ADDENDUM NO. 3

June 27, 2023

This Addendum forms a part of the Contract Documents and modifies the original Bidding Documents dated June 1, 2023.

1. A601 – DOOR SCHEDULE & DETAILS:
 - A. REVISED DOOR SCHEDULE
 - B. NOTE CLARIFICATION ON FRAME ELEVATION (F7)
2. A800 - FFE – AREA A SCHEDULE NOTES:

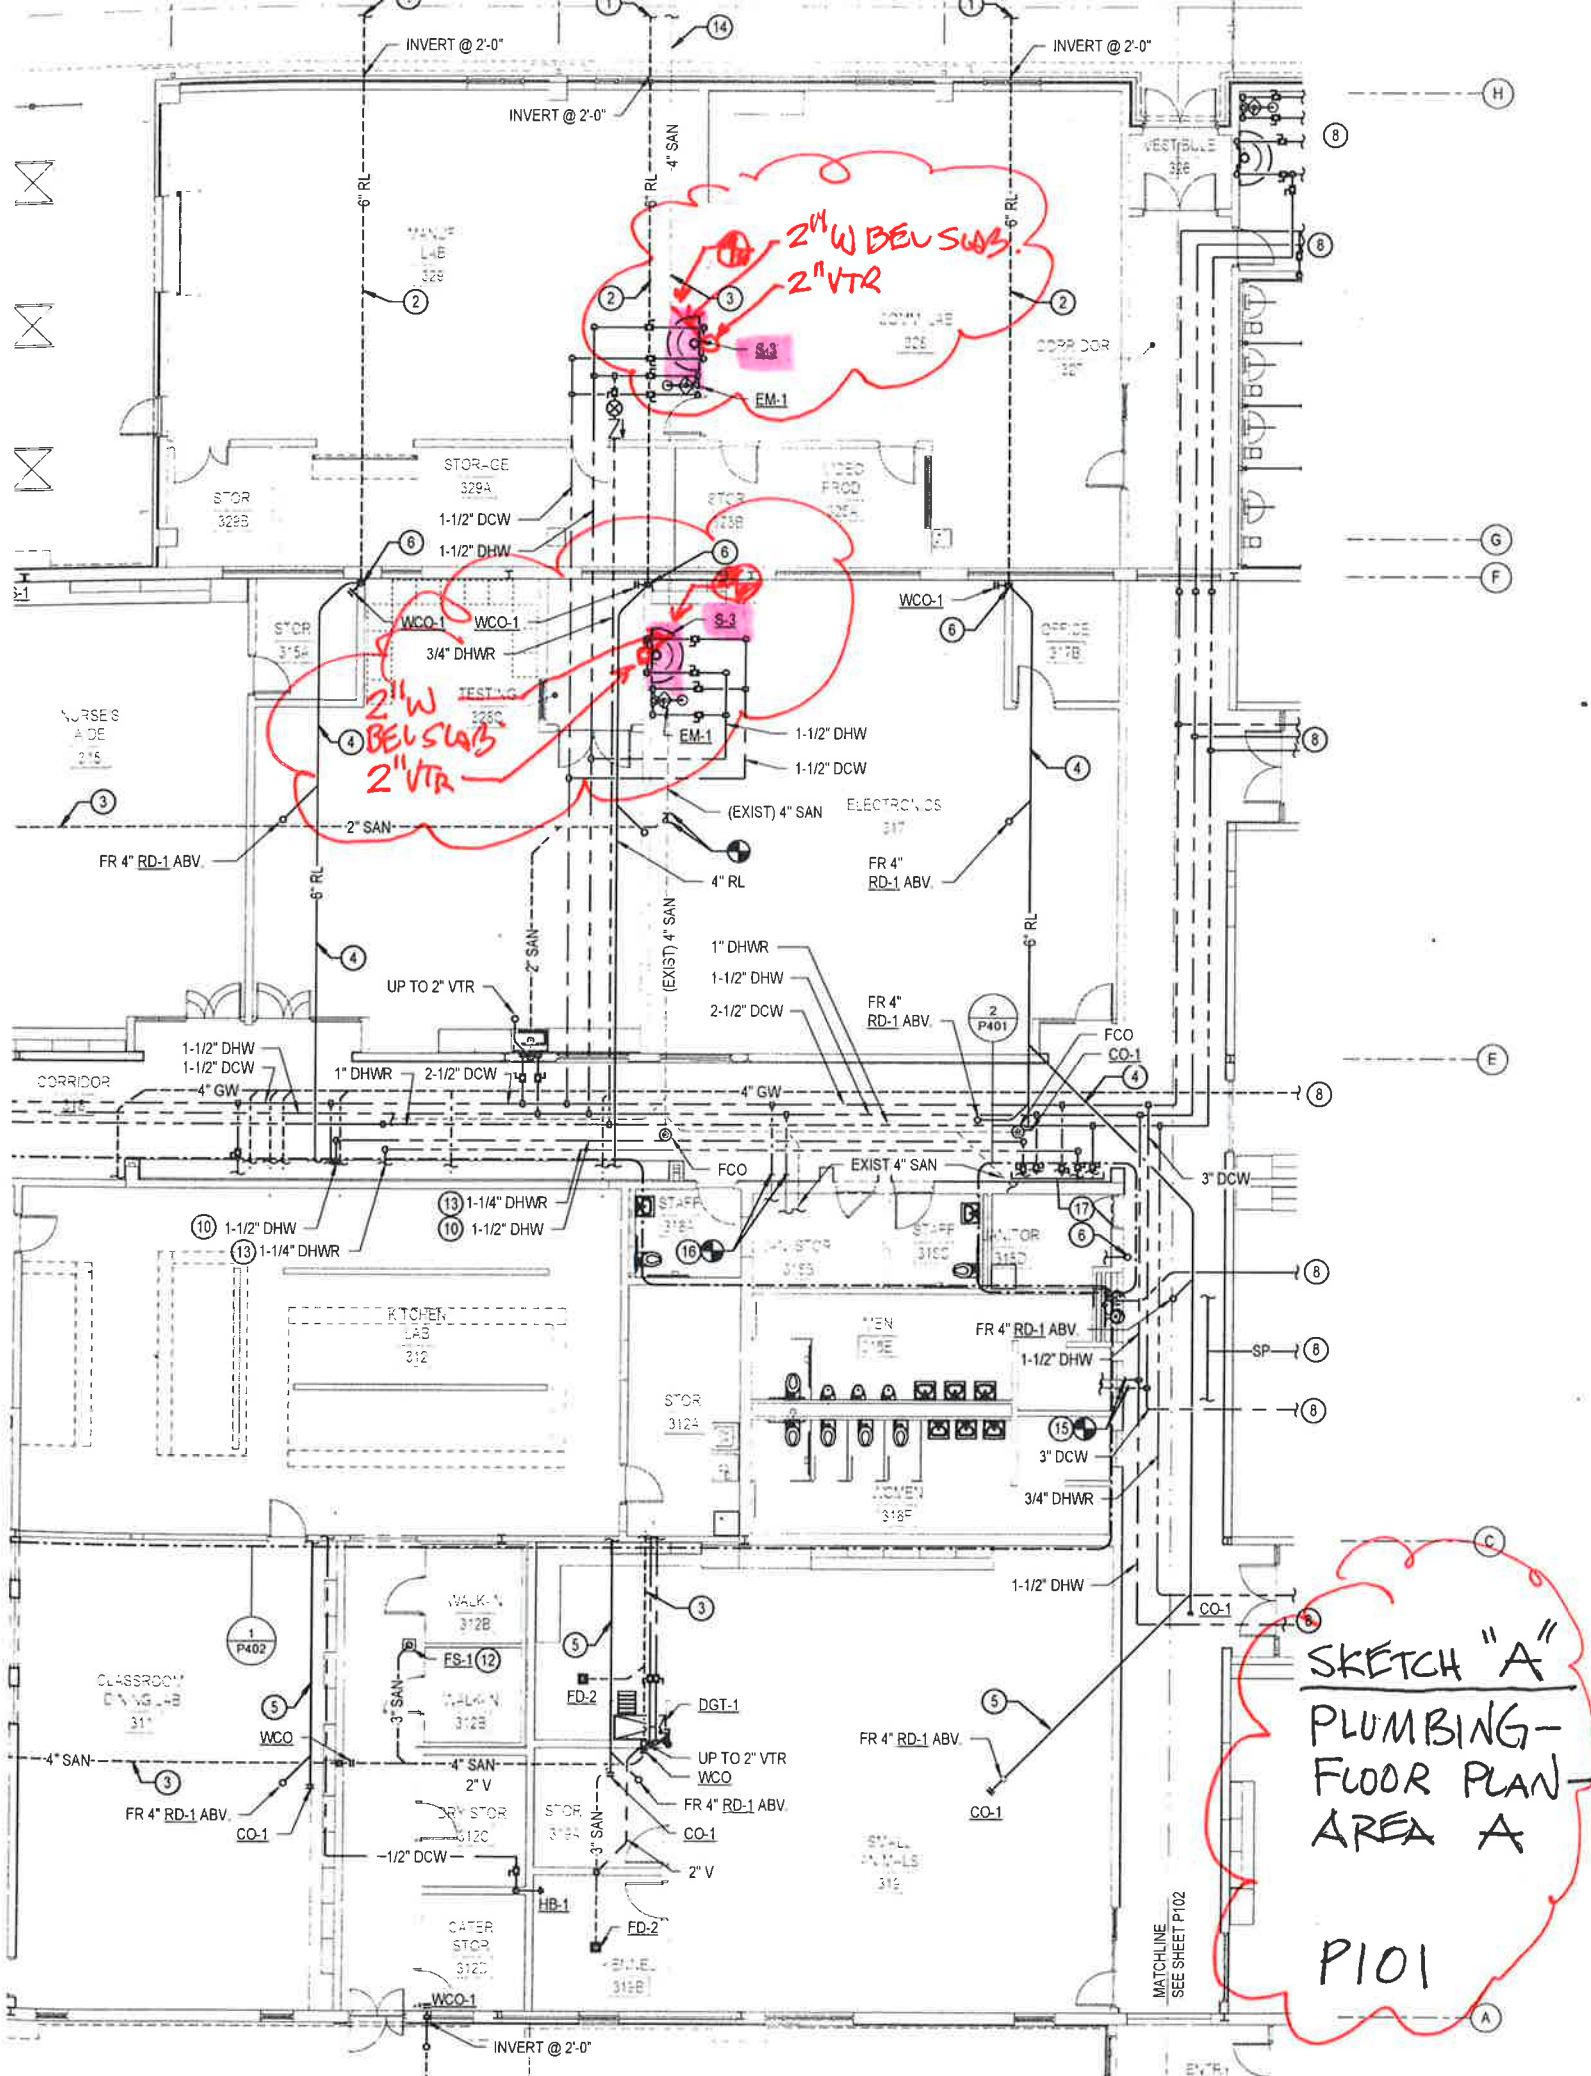
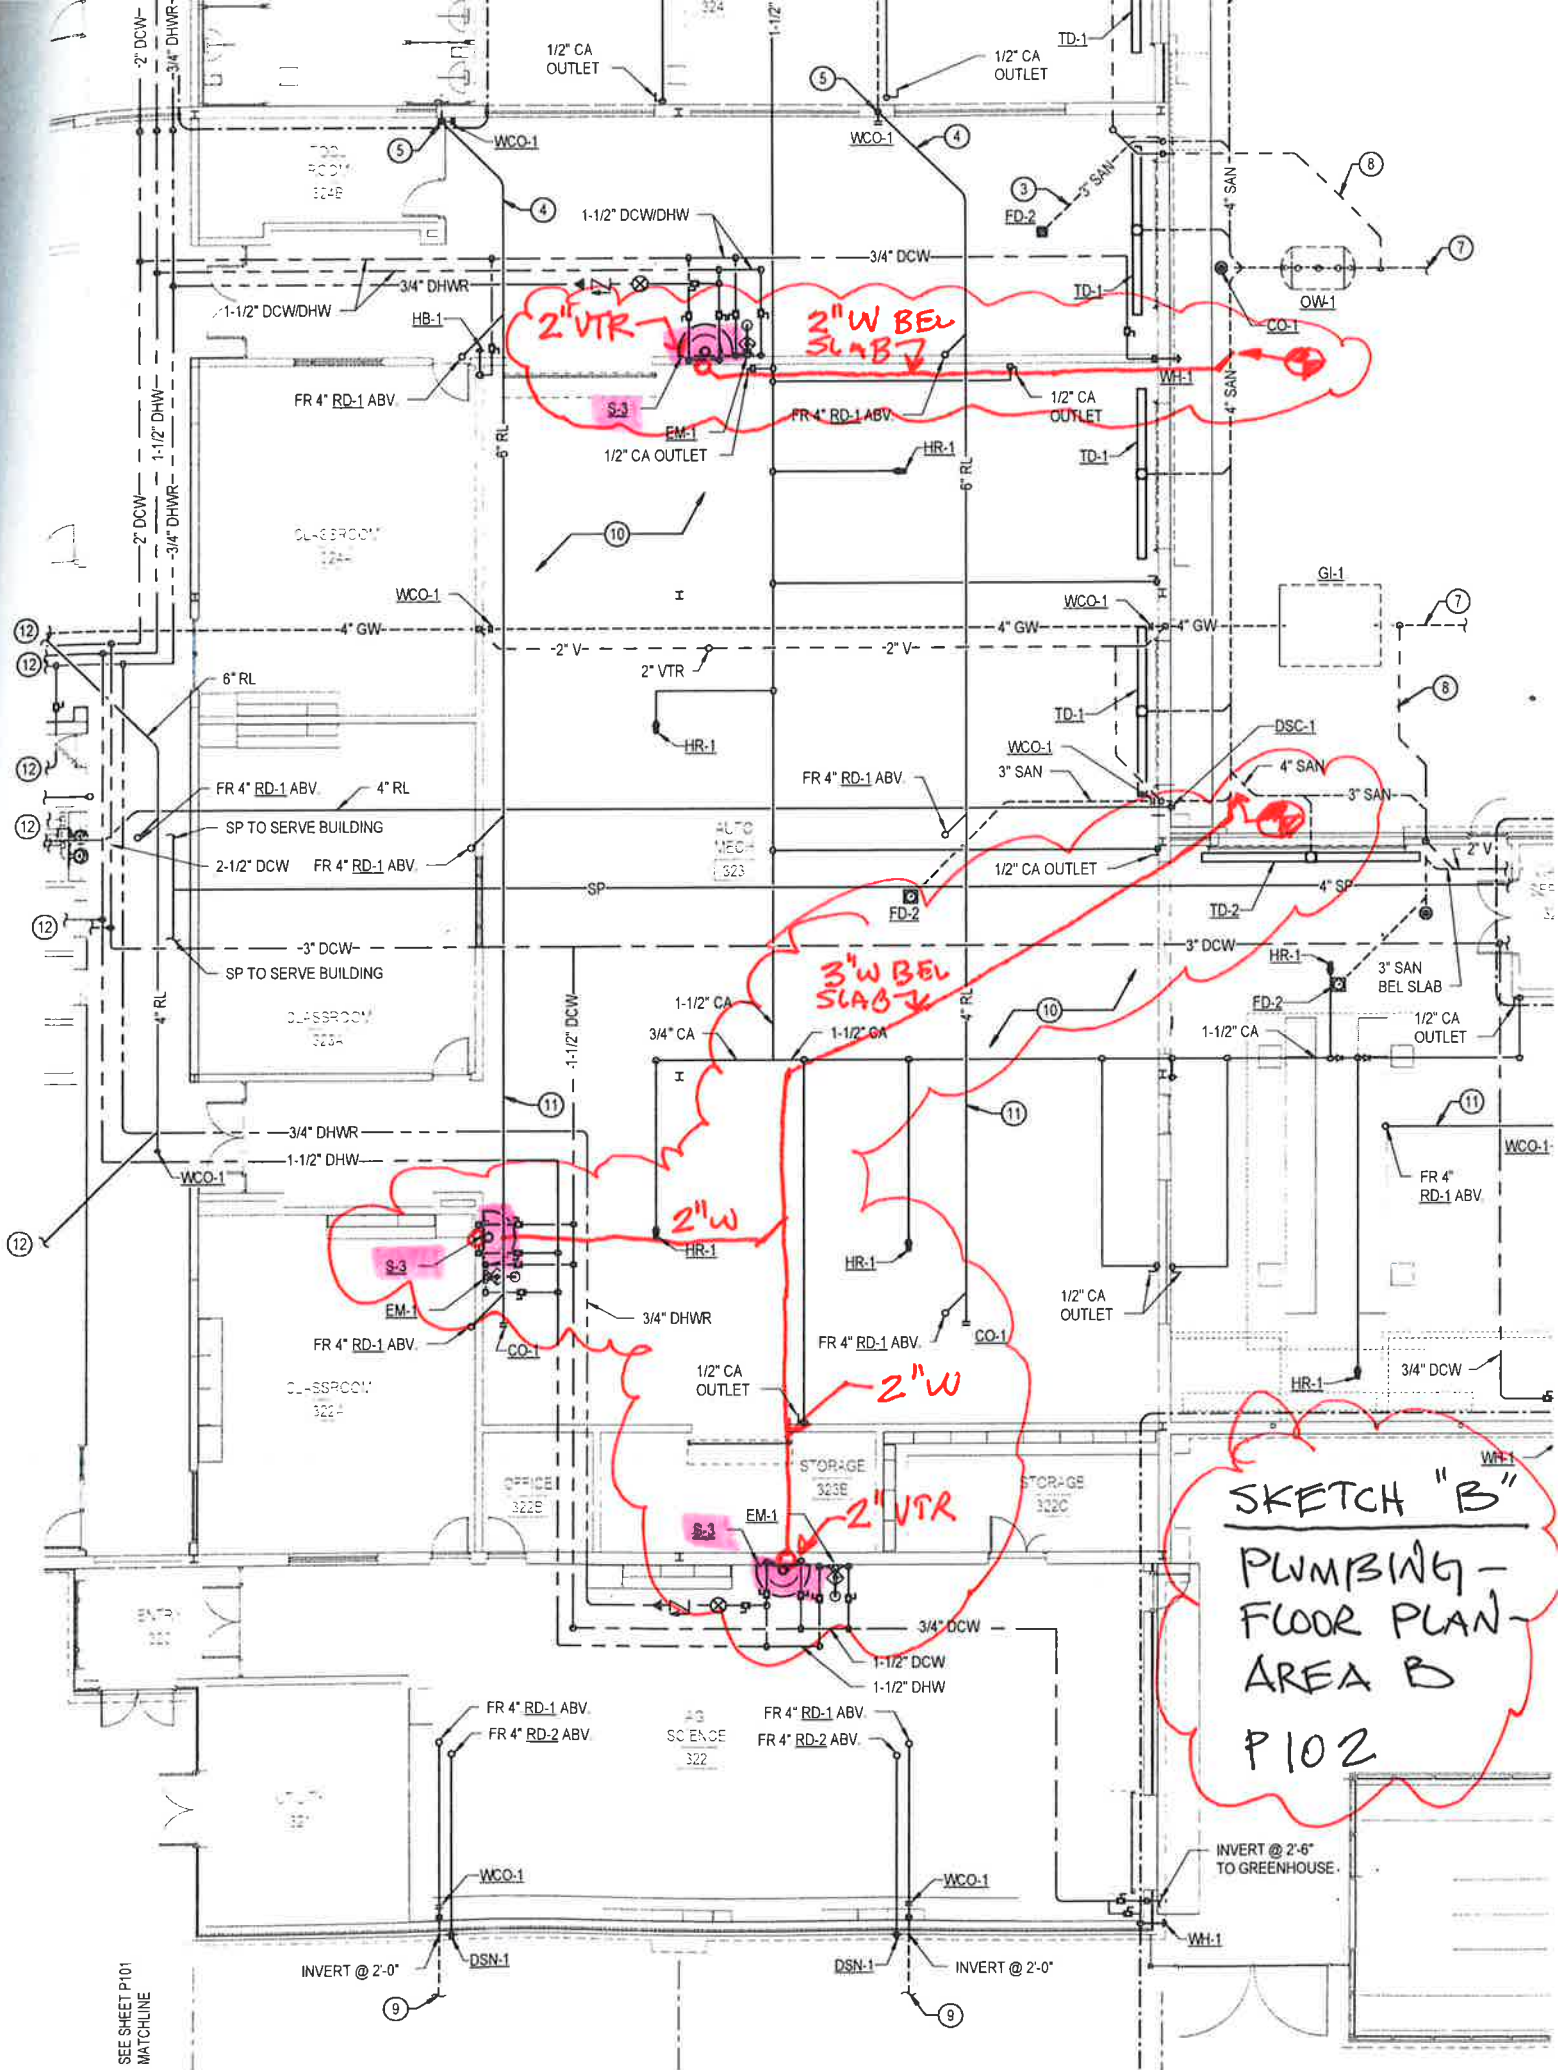
1. PREBID QUESTION – Door schedule head and jamb details for Door 310,310.1, 314, 314.1. Refer to H7 & J7. Schedule indicated material as HM- Referenced detail to A602 H& J7 indicate aluminum storefront. Which material is correct?

2. PREBID QUESTION – Opening 325.1 is an exterior door. Should it be hollow metal instead of the wood door? The frame is detailed as an aluminum frame, but it has the material as hollow metal.

- A. There are no metal panels per sheet A611. See sheet A601 frame type (F7) for location of metal panels for signage.
4. PREBID QUESTION - Openings 315 & 316 are under hardware set #26 but they are not in the door schedule. Should they be wood doors with hollow metal frames?

- A. Door frames for doors 310, 310.1, 314, & 314.1 shall be hollow metal. See revised door schedule A601 for frame type and updated head and jamb details.

- A. Opening 325.1 shall be an insulated hollow metal door. See revised door schedule A601 for frame type and updated head and jamb details.
3. PREBID QUESTION – The glass/Panel legend (drawing sheet A611) has IP for the insulated metal panels. There are no IP's on the frame elevation types only GL types. Is it safe to assume there are no metal panels?

- A. See revised door schedule A601 for door type and frame elevations.
5. PREBID QUESTION - The wood door spec has wood transom & side panels on page 5 of section 082113. Can you confirm there aren't any since the transoms have the GL type shown on sheet A601.
